2026/3095/P

188 Goldhurst Terrace NW6 3HN

Delegated Report (Members Briefing)		Analysis sheet		Expiry Date:	12/10/2026
		N/A / attached		Consultation Expiry Date:	15/10/2026
Officer			Application Number(s)		
Paul Vassiliadis			2026/3095/P		
Application Address			Drawing Numbers		
188 Goldhurst Terrace London NW6 3HN			<i>See draft decision notice</i>		
PO 3/4	Area Team Signature	C&UD	Authorised Officer Signature		
Proposal(s)					
Replacement of windows and doors on front, rear and side elevations, and installation of 4 rooflights.					
Recommendation(s):		Grant conditional planning permission			
Application Type:		Full Planning Permission			
Conditions or Reasons for Refusal:		Refer to Draft Decision Notice			
Informatives:

9. Proposed front and rear elevations. Note: due to the height of the building and angle of the roof, the roof does not appear as visually prominent in person (see images 3-7 above).

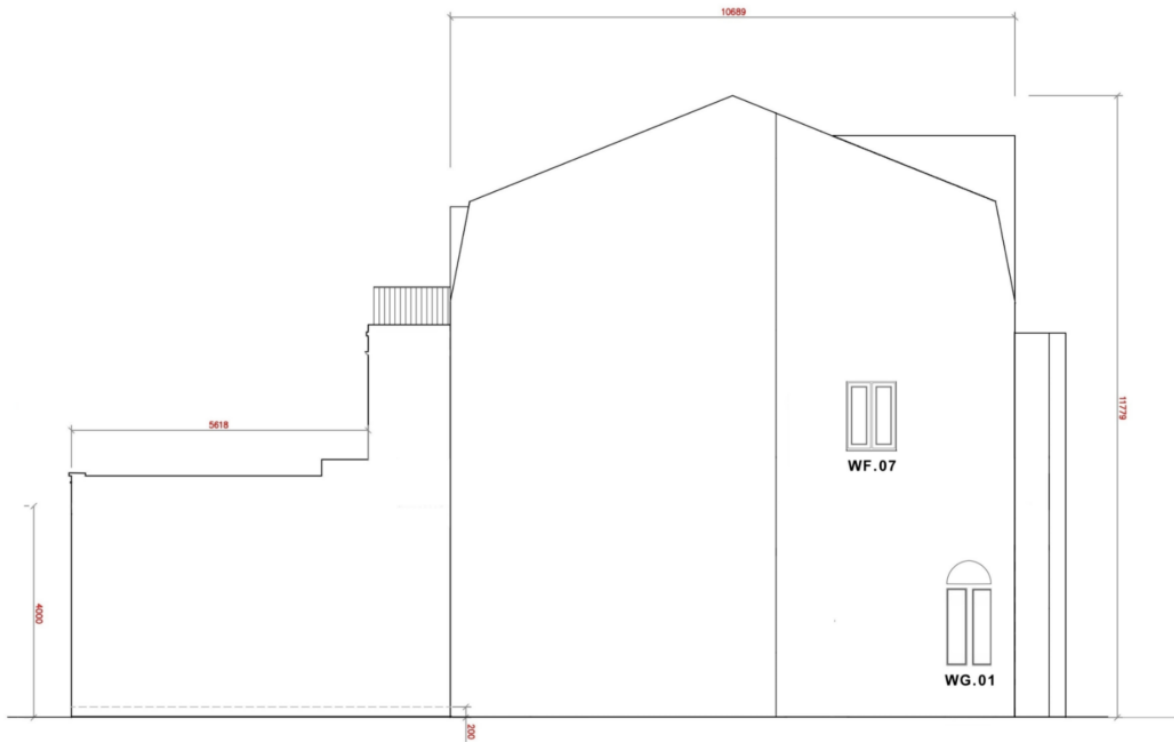
3.14 Although the rooflights are apparent on the proposed elevation drawings, the street-level site photographs demonstrate that the main roofslope is considerably less prominent in actual public views due to the height of the building, the pitch and form of the roof and the intervening roof features. The rooflights would consequently have limited visibility from Goldhurst Terrace.

11. Proposed side elevation.

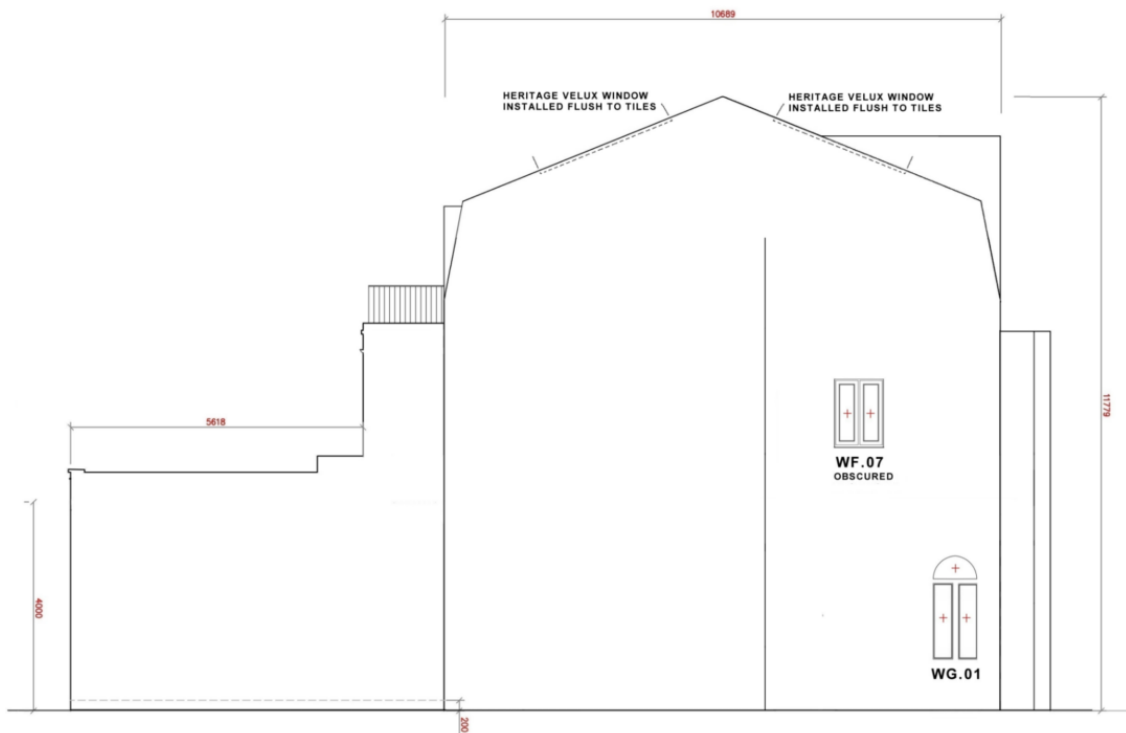
3.8 On the rear elevation at ground floor level the proposal includes a three-panel aluminium sliding door with minimal black frames (DG03). The height of the existing opening would be increased slightly to align with the existing blockwork bond. The large glazed opening and contemporary detailing would relate appropriately to the design and character of the single-storey rear extension and, given its location on the rear elevation, would not be considered visually prominent from private views within the wider conservation area.

3.9 Planning permission 2024/3529/P previously granted permission for a six-panel aluminium bifold door within the same rear elevation. This approved arrangement has not been implemented. The current proposal would retain the overall character of a large contemporary glazed opening in this location, with the principal changes comprising the reduction from six bifold panels to three sliding panels and a slight increase in the height of the opening. These changes would not materially increase the visual impact of the opening or result in any further harm to the architectural character and appearance of the building or the character and appearance of the South Hampstead Conservation Area.
